**AN ORDINANCE APPROVING AN AMEMDED FINAL  
DEVELOPMENT PLAN SUBMITTED ON BEHALF OF  
ALDI, INC., FOR 1100 S. MERAMEC STATION ROAD.**

This letter is to accompany resubmittal of the Final Development Plan for the proposed ALDI store project referenced above. In addition to the site plans, we offer the following responses to the plan review letter comments from BFA Engineering, dated March 23, 2021:

RE: 2<sup>nd</sup> Final Development Plan Review for ALDI Retail Facility  
1100 Meramec Station Rd - BFA 3497-0

OVERALL  
PLAN

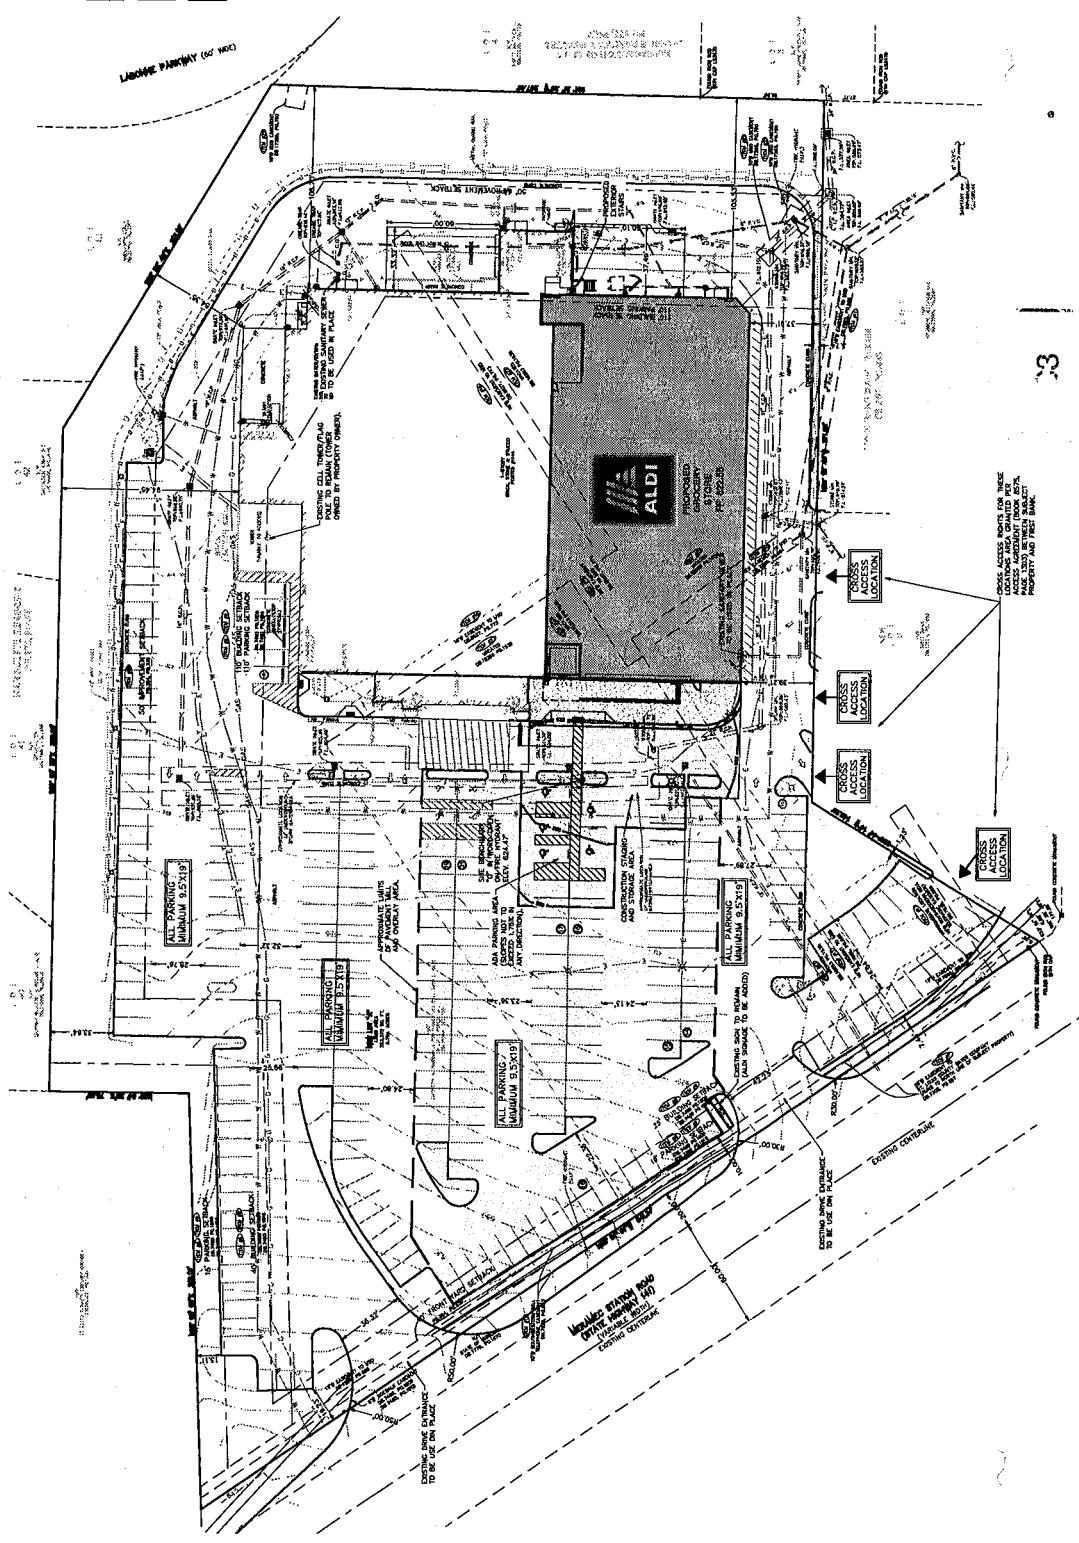
- 3) Distances between the building and the property lines are shown on Sheet C03. These have been labeled from the nearest property lines on the east and south sides of the lot.

- 4) Building and parking lot setbacks are shown on Sheet C03.
- 5) Dimensions of driveways, parking lots, aisles, loading and service areas and docks have been added to Sheet C03.

1. Display and call out all proposed and existing public street center line locations per Section 400.340 A.4.b.  
This comment is addressed.
2. Display and call out all proposed and existing public street widths, curb cuts, and radii per Section 400.340 A.4.c.  
This comment is addressed.

3. Call out distance between building and property lines and between parking areas and property lines per Section 400.340 A.4.f.  
This comment is addressed.

4. Call out all required buildings and parking setbacks per Section 400.340 A.4.g.  
This comment is addressed.
5. Please provide dimensions of all driveways, parking lots, aisles, loading and service areas and docks per Section 400.340 A.4.j.  
This comment is addressed.

Luminaire Schedule

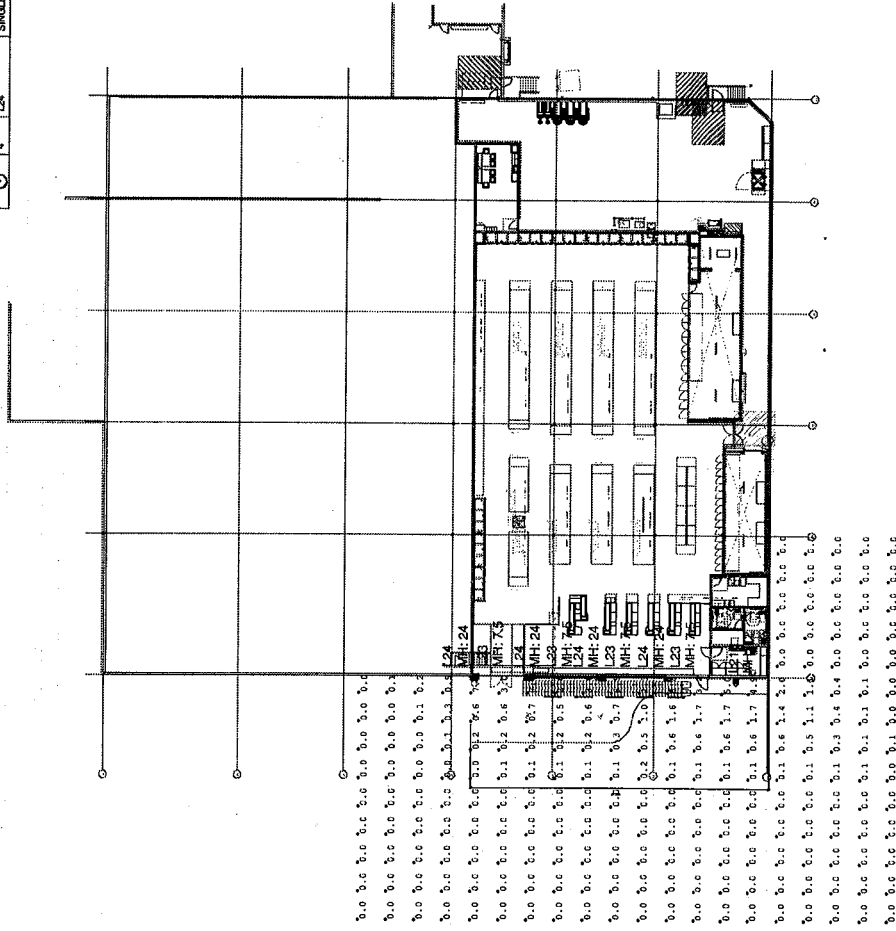
6. Please include the photometric plan sheet, "ALDI - 2101050KMOLIS", to the final development plan set. Please include the lighting cut sheets to the final development plan set. There is no cut-sheet for L24 (as called out on the photometric plan sheet). The light fixture for EMX and Poseiden, as provided in the cut sheets, are not shown on the photometric plan. Please ensure all light fixtures are adequately labeled and comprehensible. Please identify all required items such as light's location, height, and type as per Section 400.340 A.4.k.  
This comment is addressed.

- 6) Revised photometric plans are included in this resubmittal. This includes the plan 'ALDI-2101050KMOLJS', which shows the fixtures adjacent to the building (and their mounting height 'MH' shown) and lighting cut sheets (including cut sheet for L24, AKA 'Poseidon'). A second photometric plan is attached that encompasses the entire site. This additional plan is intended to show conditions in the parking lot and at the property lines. Fixture EM-X is not shown on the plans as this is an emergency only light.
